## Technical Memorandum

Subject: I-15 from Flamingo to Sahara: Ultimate Ideas Review Memorandum – Revision 1

### **PROPOSED MLK EXTENSION DESIGN REVIEW ITEMS**

**Figure 4 – Idea No. 17 - Roundabout Interchange Configuration at Spring Mountain Road**

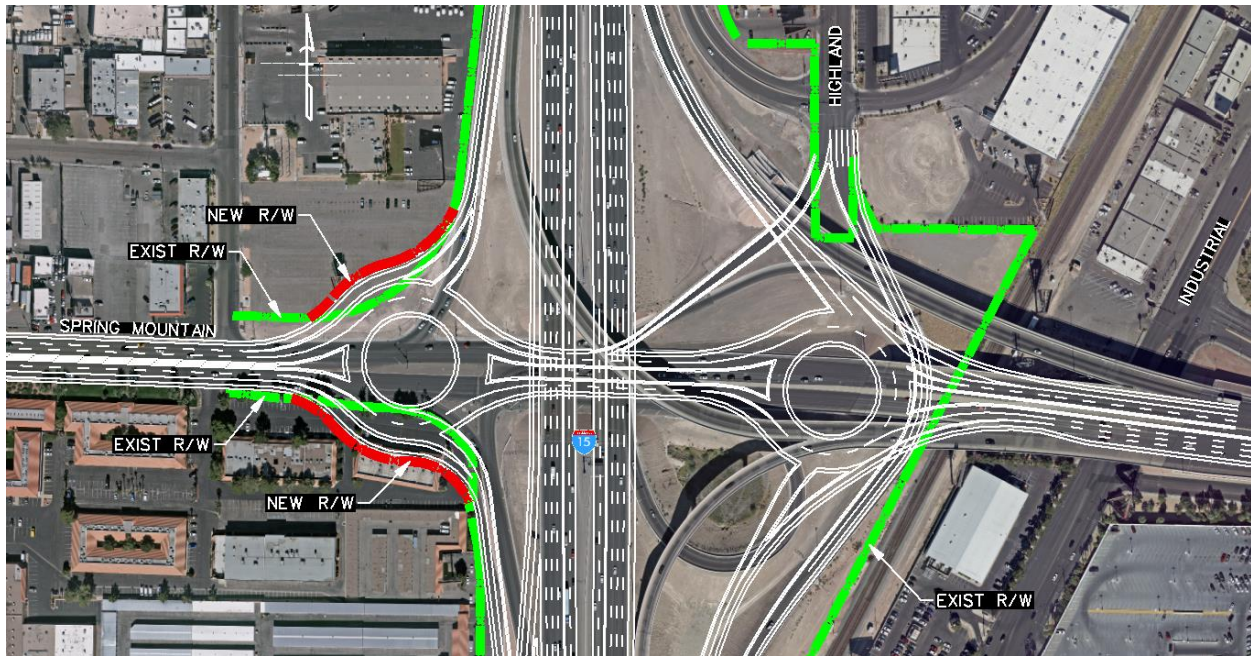
It is not feasible to reconstruct the I-15/Spring Mountain Road interchange to roundabouts. The roundabout on the west side of I-15 would require a substantial right-of-way acquisition, as shown in Figure 4. This idea also not feasible because of high traffic volumes and roundabouts may not operate efficiently with high traffic volumes. The traffic volumes are based on the design year (2040). Idea No. 17 is not recommended for further analysis.

**Figure 5 – Idea No. 50 – Tropicana Avenue SB off-ramp and Flamingo Road SB on-ramp**

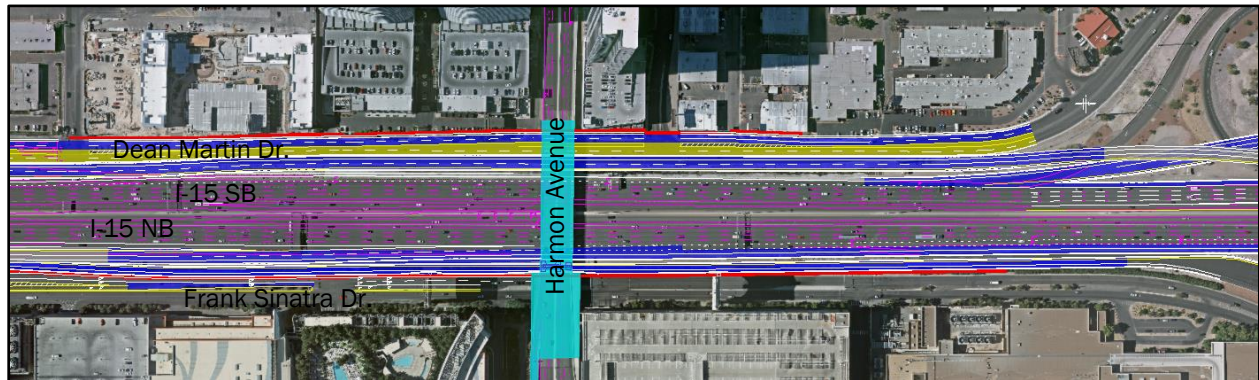
During the concept evaluation, it was found that due to the proximity between Dean Martin Drive and SB I-15 between Tropicana Avenue and Flamingo Road, the existing right-of-way could not accommodate the 1-HOV and 5-GP lanes on SB I-15, HOV ramps from Harmon Avenue, and a SB CD

road to Tropicana Avenue lane configuration. It is recommended to acquire additional right-of-way and to restripe Dean Martin Drive between Flamingo Road and Tompkins Avenue (see Figure 5).

**Figure 6 – Slip-Ramp from EB CC 215 to NB I-15**

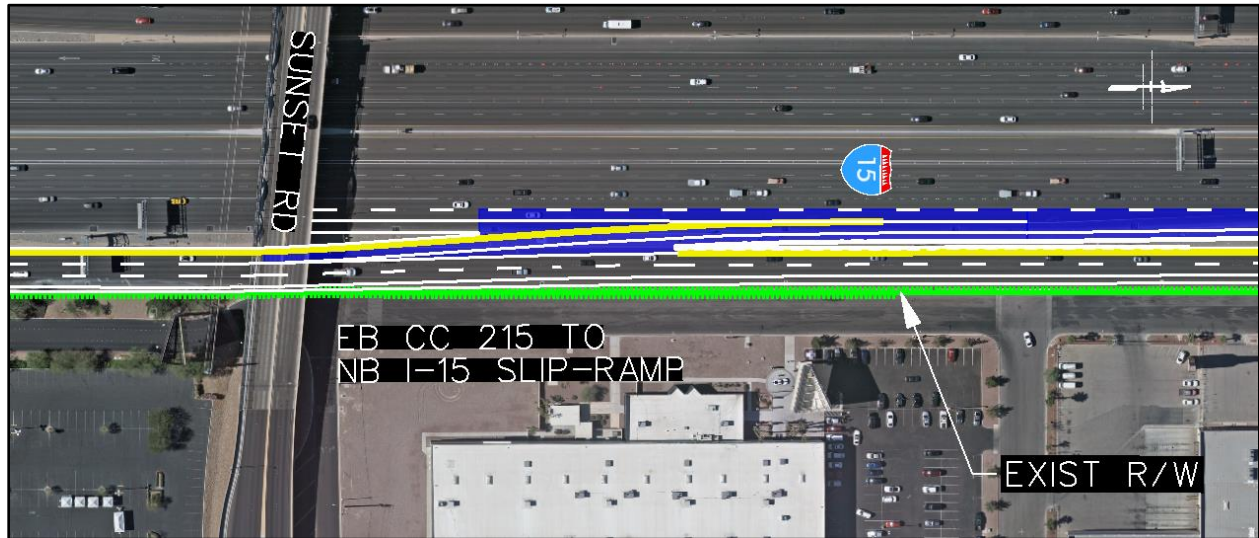
It is recommended to merge CC-215 EB to I-15 NB with a slip-ramp at Sunset Road as seen in Figure 6. The Tropicana Avenue and Russell Road off-ramps from NB I-15, I-215 EB and CC-215 EB would be combined through the NB CD road. The NB CD road would then be braided with the Russell Road NB on-ramp. Shift and maintain the second Tropicana Avenue off-ramp located south of Russell Road by a 1000 ft to the north. This would allow a greater weaving distance between WB I-215 to NB I-15 and Tropicana NB off-ramp.

**Figure 7 – Idea No. 65 – DDI Configuration at Spring Mountain Road – Grade Separated and Conventional Cross-over**

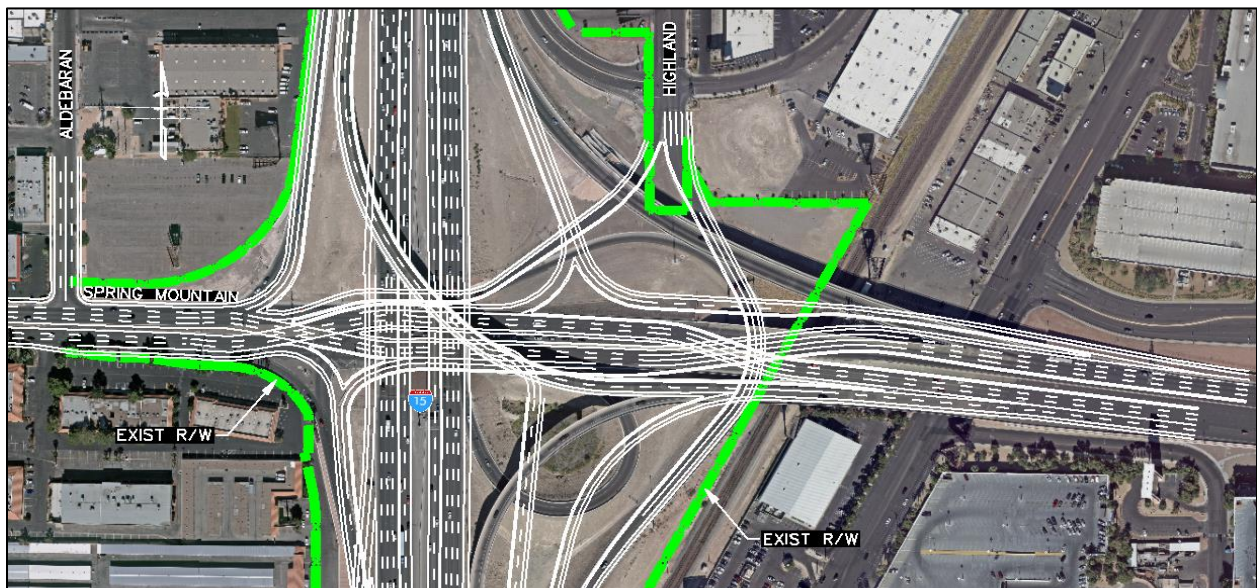
It is feasible to construct a modified DDI at Spring Mountain Road with the eastern crossover grade-separated and with the western typical crossover with a traffic signal at the crossover.

The existing access to the property on the southwest corner of Spring Mountain Road and I-15 would be relocated from Spring Mountain Road to Polaris Avenue for the DDI configuration to operate efficiently (see Figure 7).

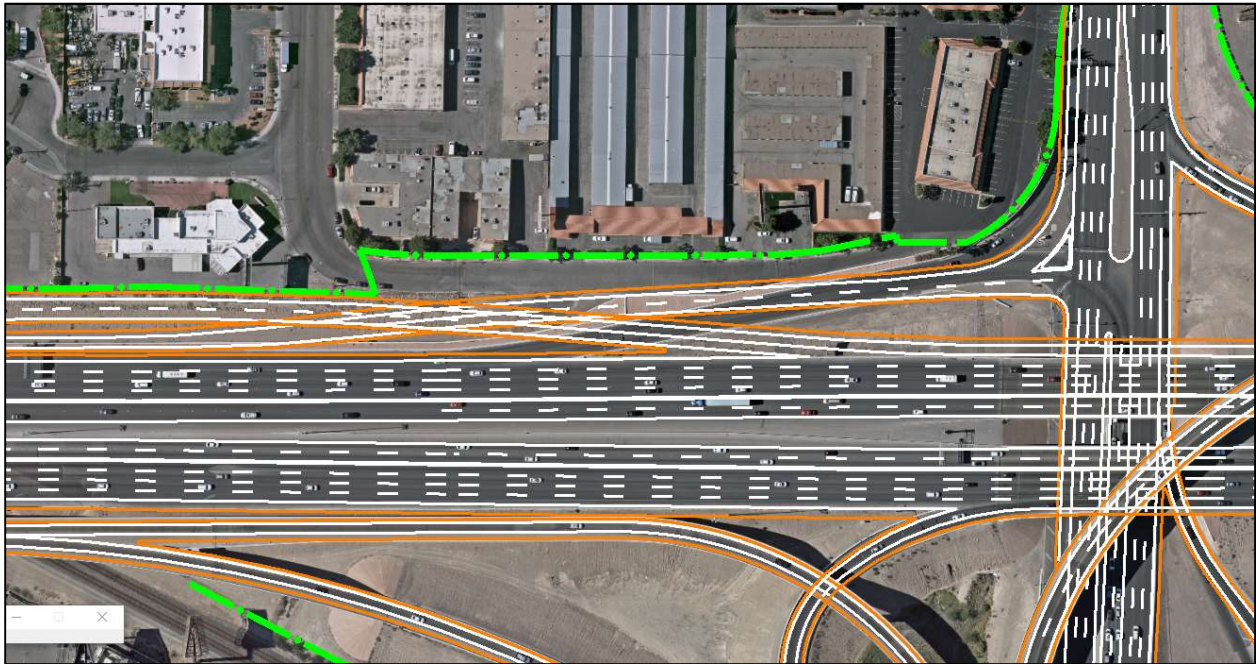
- The EB storage length could be increased by approximately 200’ (need Traffic Operation Analysis to warrant the storage length)
- The ramp entry angle is decreased with a 20’ lane at the island. The turning radius allows traversal by a WB-67.
- The painted gore to painted gore spacing between the Spring Mountain entrance and Flamingo WB exit on SB I-15 is approximately 1570 feet. The Spring Mountain ramp entrance and Flamingo WB exist ramp could be adjusted and extend the two-lane storage from the ramp meter stop bar.
- The existing on-ramp could also be widened to the inside to provide a 3 lane on-ramp up to the meter location,

It is recommended that NDOT consider implementing a modified geometry and added ramp meter lane at the SB ramp entrance to increase storage for the EB to SB turn lane and expand the ramp meter storage in the interim. The existing geometry does not provide adequate storage, and ramp metering operation develops queues into Spring Mountain.

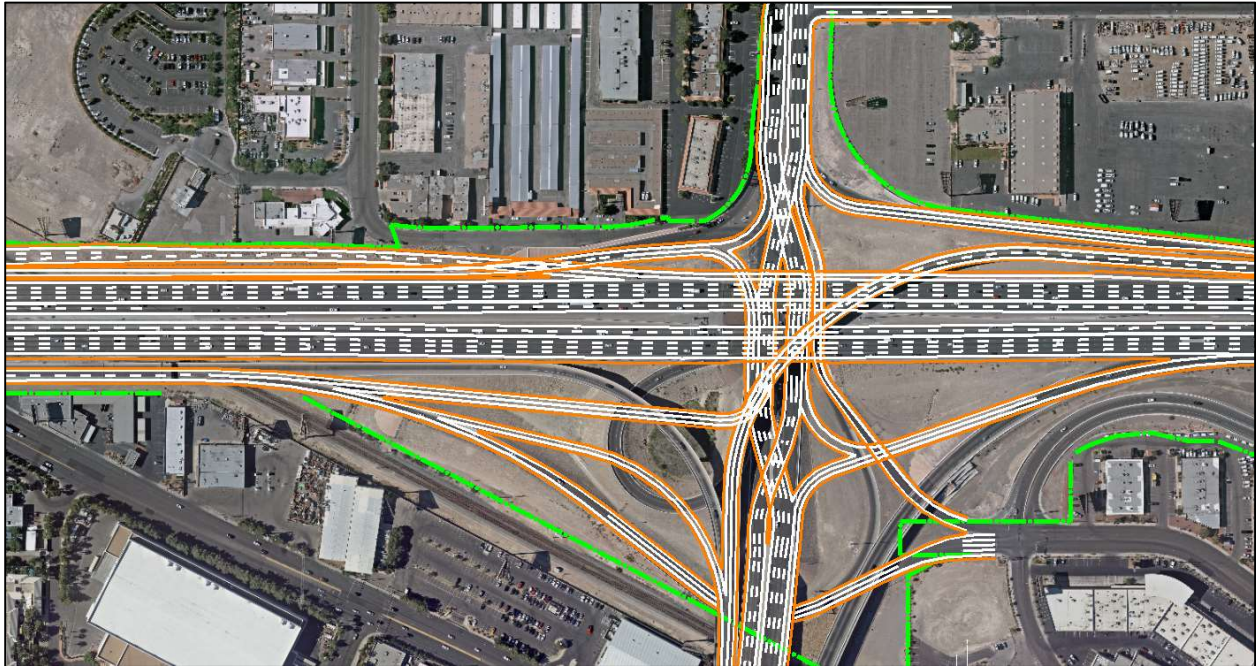
*Elimination of access to Highland Dr. could be politically problematic. Removing the access to Highland Dr could be separate from converting Spring Mountain Rd to a DDI, which is already documented in another idea. The idea to remove direct access to Highland Drive without reconstructing the interchange will be considered as an interim improvement.*

- This idea, as an interim improvement, would be to remove the Highland access from the existing interchange movements. Reconfiguration of the interchange to a DDI, or a modified DDI will be evaluated as an ultimate concept.
- The removal of access may slightly enhance the operation of the interchange, but it will adversely impact local access, causing traffic to have adverse effects to adjacent interchanges and the intermediate roadway network.

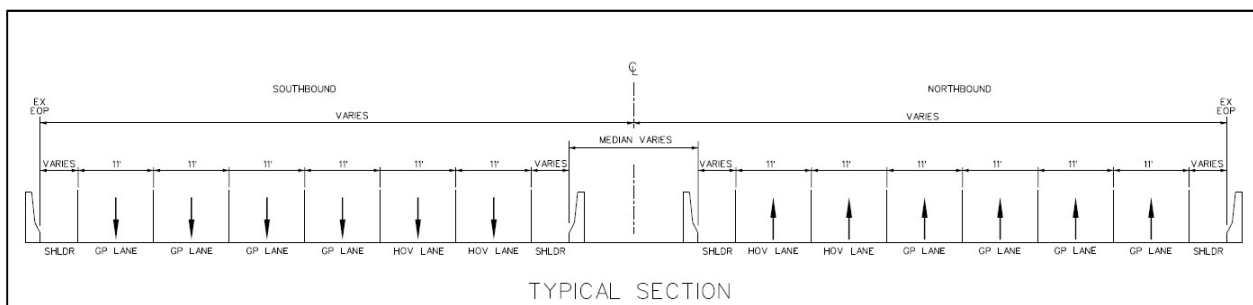
Use of 11' lanes may allow an extra 10'-15' of space or allow room for an additional lane. The sketch below shows the approximate width needed between Tropicana Ave and Flamingo Rd - exclusive of the space needed for on-/off-ramps (if there are any in the final configuration). There will be many other constrained areas in the corridor. Eleven-foot lanes are commonly used in Seattle area and are not considered a "deviation". AASHTO allows for 11' lanes except in high truck volume areas.

NDOT to consider 11' lanes for all projects to maximize ROW utilization, this can happen without any other improvements. Considered an interim improvement. Need to provide a continuous lane or not valuable. Defer to idea development.

Figure 1

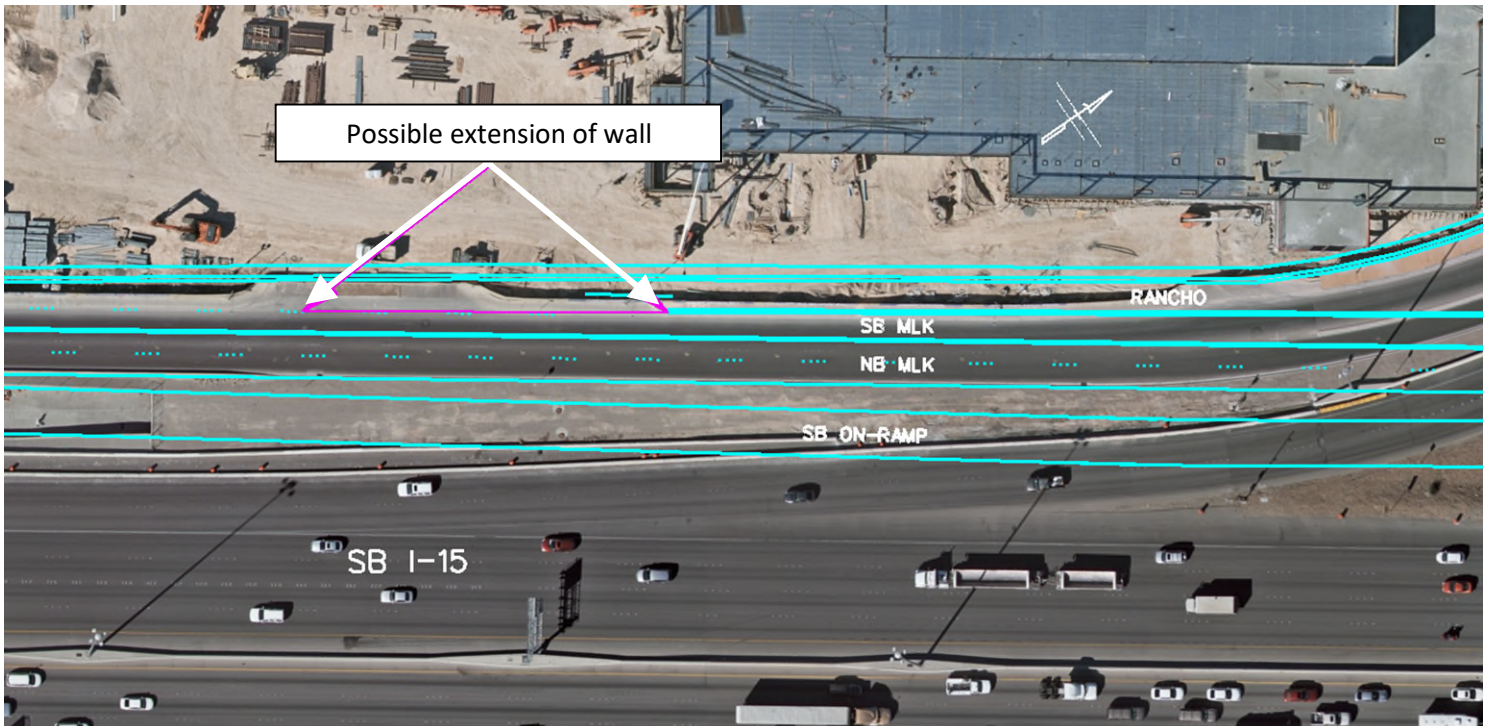
- a) The proposed retaining wall between southbound Rancho and the proposed MLK Extension should be extended from the current design so that the two roadways are allowed to match vertically (see Figure 1). The MLK Extension is grade separated over Sahara, the southbound (SB) I-15 to eastbound (EB) Sahara off-ramp, and the EB Sahara to SB I-15 ramp, then MLK's profile lowers to match in to and merge with the existing Rancho roadway. Only the SB connection from Sahara is perpetuated. Northbound (NB) Rancho would not have direct access to/from Sahara.

The retaining wall between MLK and Rancho should be extended by approximately 200 feet where the two roadways can match vertically. Options to perpetuate the existing NB Rancho access to Sahara should be considered.

Figure 2

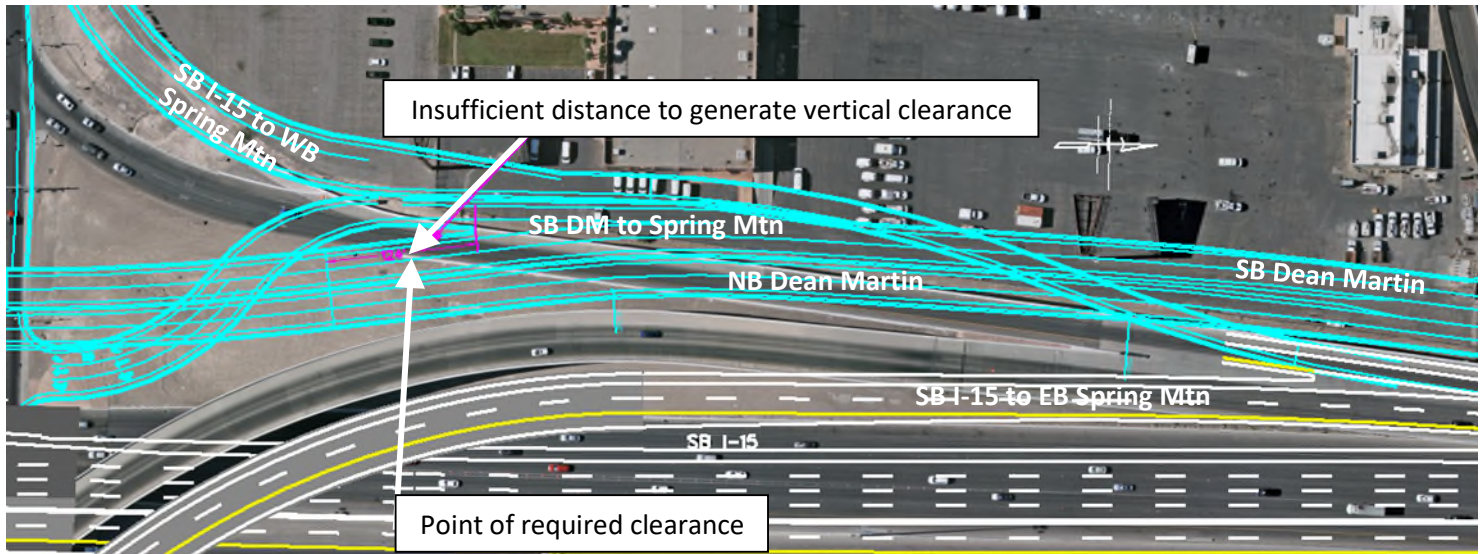
- b) As drawn, the proposed ramp geometry from the MLK Extension to Eastbound (EB)/Westbound (WB) Spring Mountain does not allow development of the minimum vertical clearance of 16.5 feet at the required point (see Figure 2).

There are several options that could be considered to resolve this:

**Figure 4**

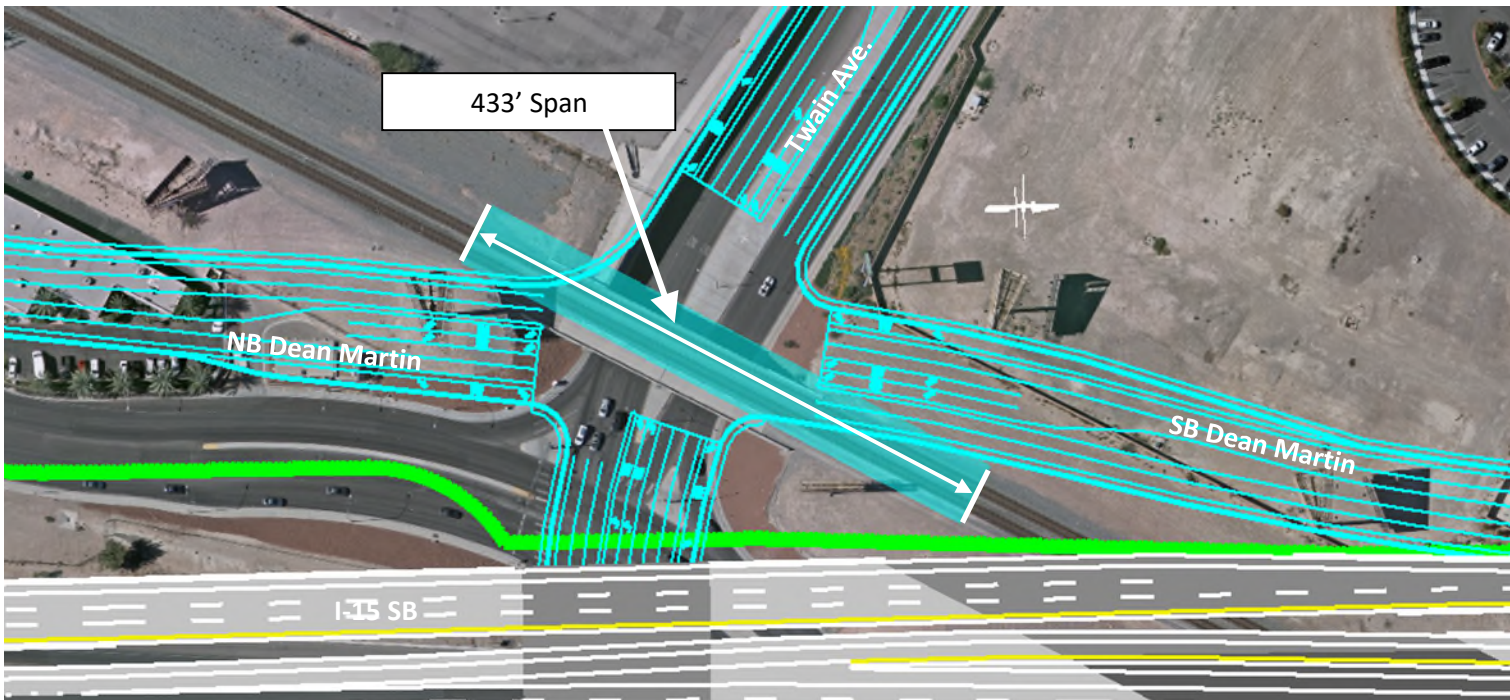
- g) The proposed intersection of MLK Extension and Twain requires a modification or replacement of the Union Pacific Railroad (UPRR) bridge (see Figure 4). The proposed configuration shows a clear span in excess of 433 feet that may not be feasible using bridge types permitted by UPRR.
